Technical Service Information

MAZDA MPV R4A-EL NO 4TH GEAR CONDITION INHIBITOR SWITCH CORRECTION

Figure 1

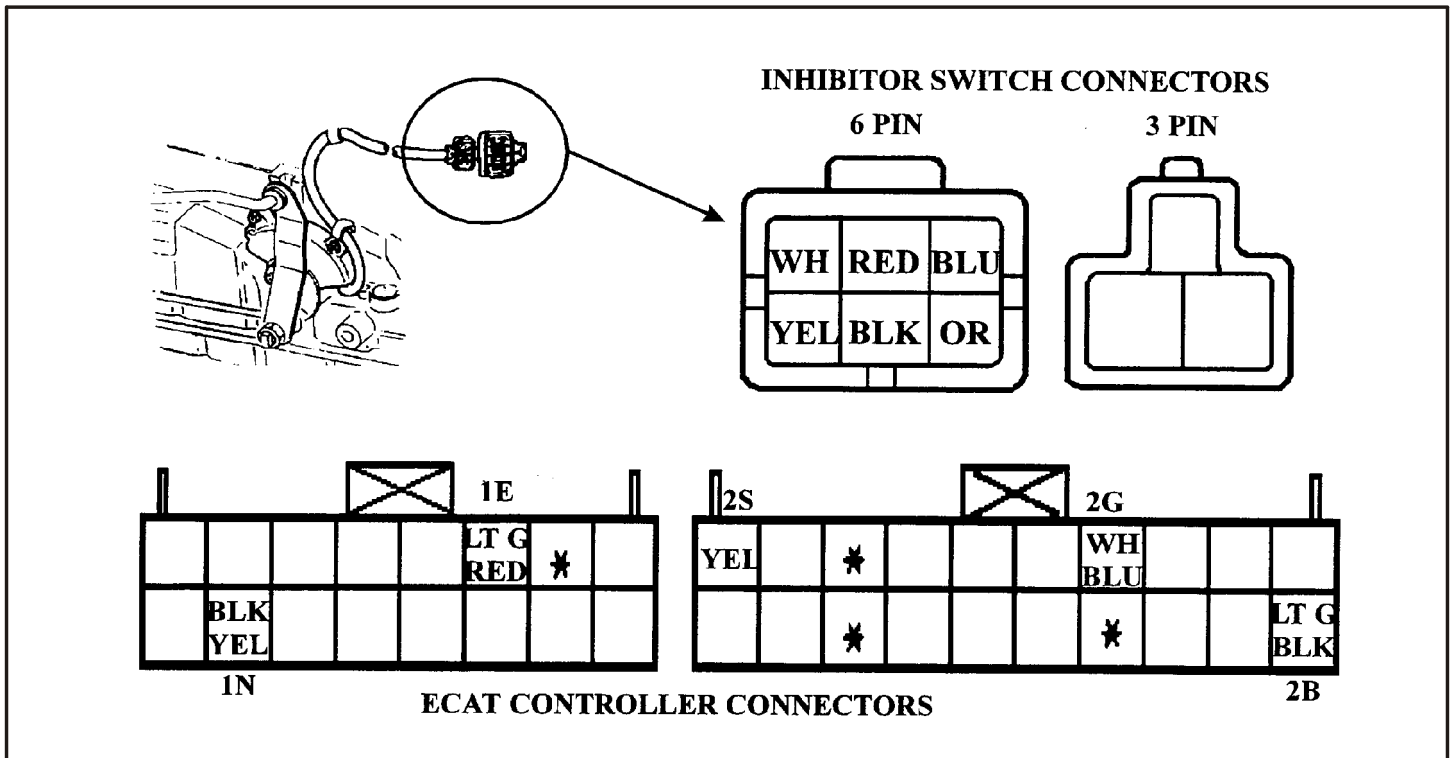
CAUSE: The cause may be, the NEW Inhibitor Switch wired incorrectly at the factory. The Red and Orange wires were inadvertently reversed in the 6 pin connector. Figure 1 shows the Red and Orange wires in the correct locations. The 3 pin connector is NOT affected.
The wires that have been mislocated (Red and Orange) must be removed from the 6 pin connector and relocated to their proper locations. Figure 1 shows the Red and Orange wires in the correct locations.

CORRECTION: Make certain that the wire colors and locations in the inhibitor switch 6 pin connector, match the wire color and location in the ECAT control unit, as it is shown in the charts and illustrations in Figure 1.

INHIBITOR SWITCH		ECAT CONTROLLER
WHITE	connects to	YELLOW
RED	connects to	LT. GREEN/BLACK
BLUE	connects to	LT. GREEN/RED
YELLOW	connects to	BLANK
BLACK	connects to	BLACK/YELLOW
ORANGE	connects to	WHITE/BLUE
